SERVICE INFORMATION NO. SI 40-029

GTX 327 or GTX 32 Software upgrade
ATA-Code: 34-00

SOFTWARE SERVICE BULLETIN

SUBJECT: GTX 327, GTX 32 Software Upgrade to Version 2.09 for non-G1000 applications only

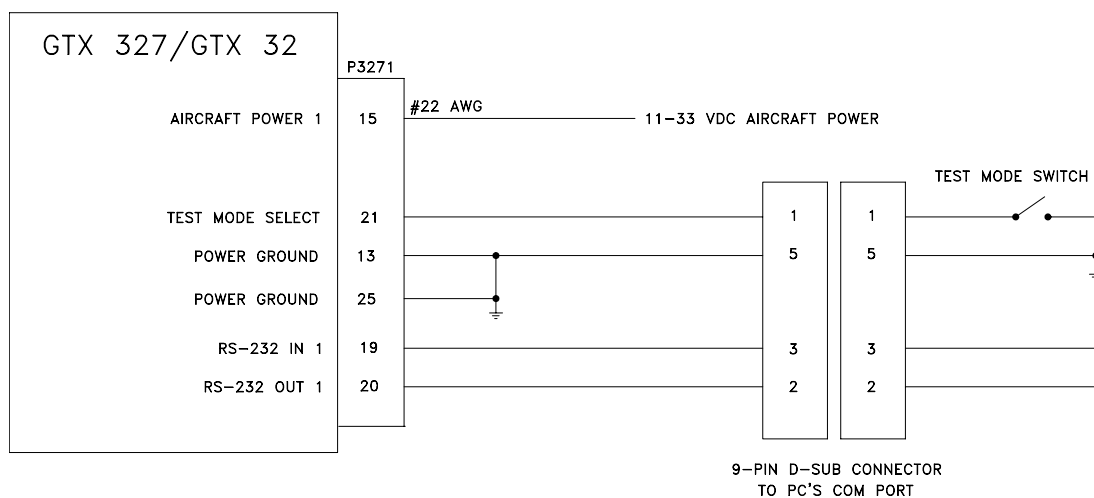
1. Assemble a test harness for the GTX 327/32 as shown in the following figure:

2. Ensure that the unit is turned off. Connect the GTX 327/32 to the test harness and apply power to the harness.
3. With the unit off, enable test mode via the Test Mode Switch. (Applies a ground to P3271 pin 21).
